UNITED STATES PATENT AND TRADEMARK OFFICE

APPLICATION NO.	FILING DATE	FIRST NAMED INVENTOR	ATTORNEY DOCKET NO.	CONFIRMATION NO.
10/652,326	08/29/2003	Anand A. Kekre	VRT0098US	1638

Office Action Summary	Application No.	Applicant(s)	
	10/652,326	KEKRE, ANAND A.	
	Examiner	Art Unit	
	Khanh B. Pham	2166

DETAILED ACTION

Teloh's Fig. 9**FIG. 9****Applicant's Fig. 3.**

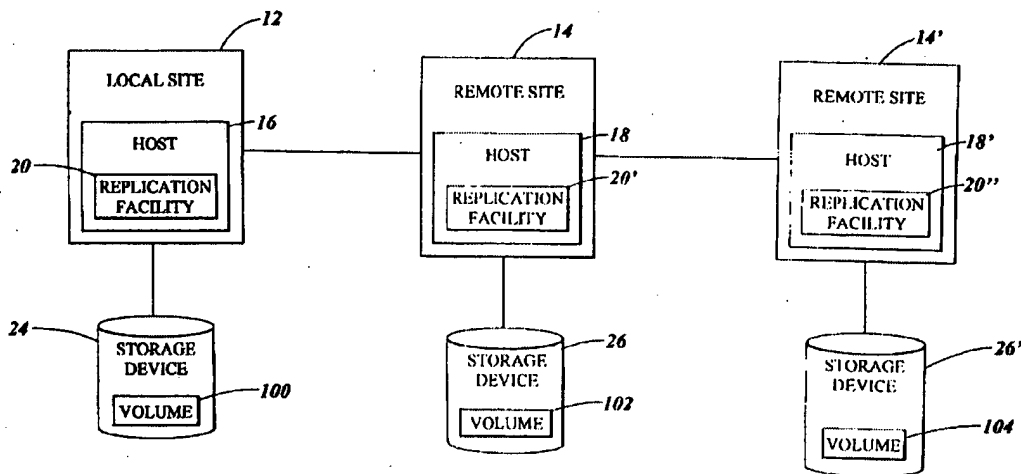
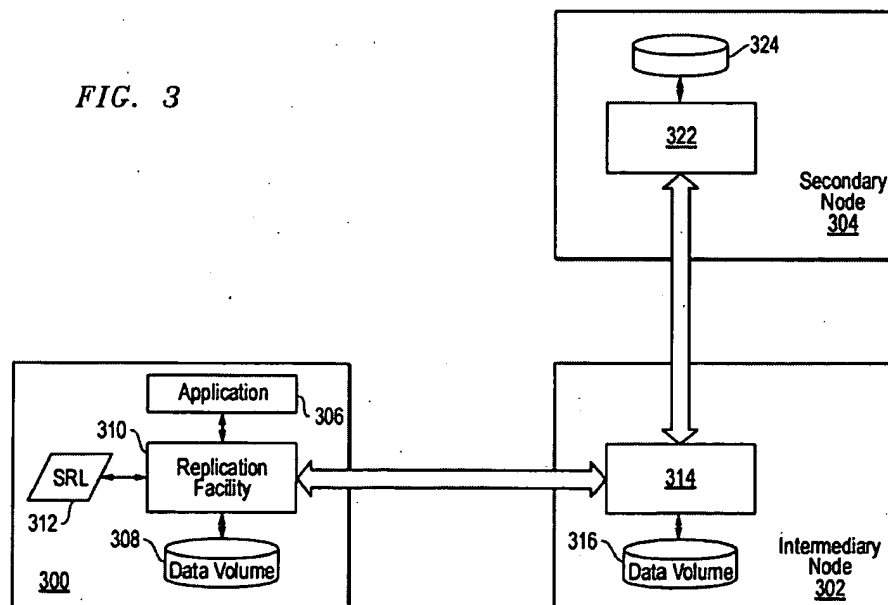
Regarding claim 3, Applicant argued that Teloh's Fig. 1 shows only two nodes 12 and 14 and therefore does not anticipate independent claim 3. The examiner respectfully submits that the Office Action rely on Fig. 9, not Fig. 1, in the rejection of claim 3. Teloh's Fig. 9 shows an identical system to applicant's Fig. 3. Teloh also

teaches at [0048] the step of mirroring data from a host to a remote site utilizing asynchronous data replication.
